Subject: CAP Modification Plan Addendum for the Former Pacific Electric Motors Site, 1009 66th Avenue, Oakland, California (Fuel Leak Case Number RO0000411)

Cap Modification Plan Addendum

Former Pacific Electric Motors Facility, 1009 66th Avenue, Oakland, California
(Fuel Leak Case Number RO0000411)

December 4, 2014

BUILDING 300 CAP MODIFICATION PLAN

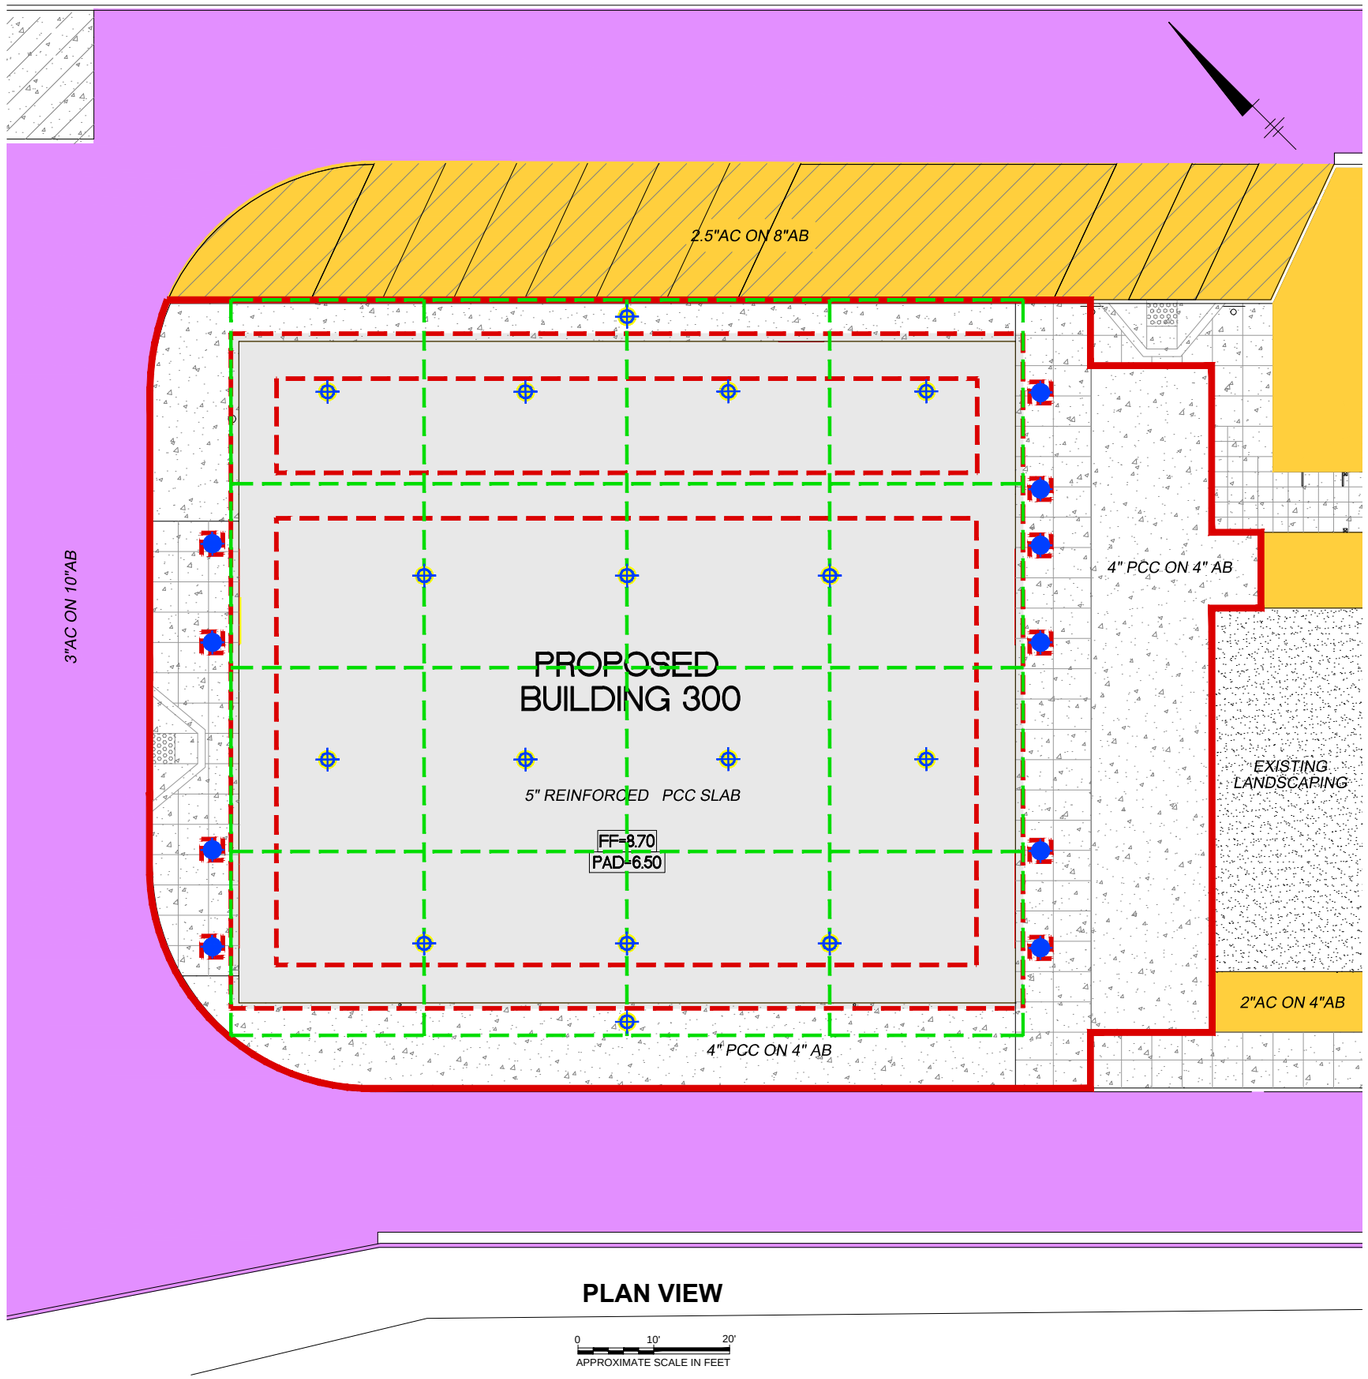
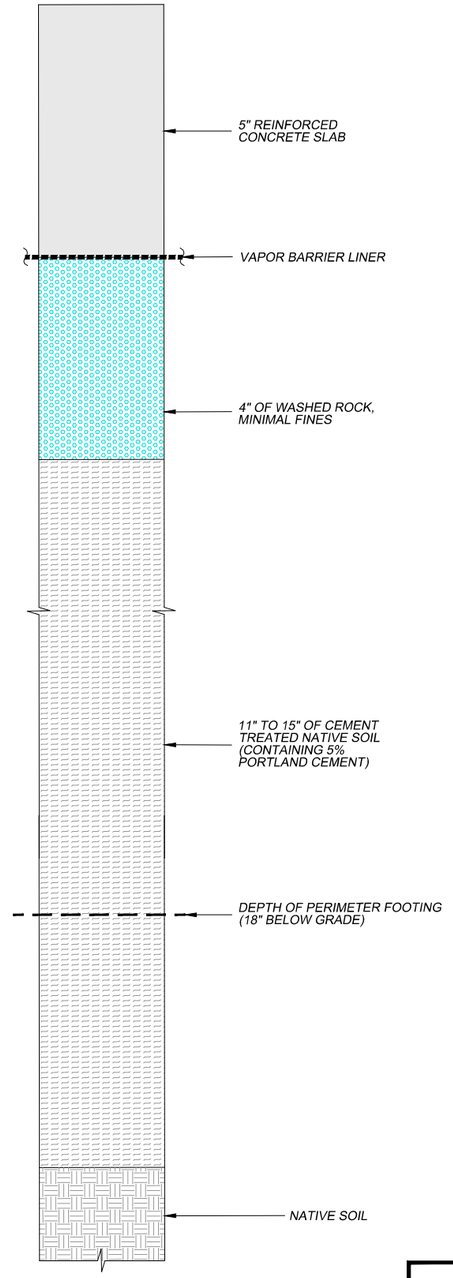
- Fourteen additional soil boring locations were added to the area of the proposed building footprint (Figure 3); soil samples will be collected only from the cement-treated native soil layer.

- Soil samples will be collected only from the cement-treated native soil layer for the two sample locations outside of the proposed building footprint (Figure 3).

ARCADIS will advance an additional fourteen soil borings to a depth of between 0.5 and 1.0 feet bgs. Soil boring locations are shown on Figure 3. The proposed locations are positioned within the proposed building footprint in a 25 feet by 25 feet hexagonal grid.
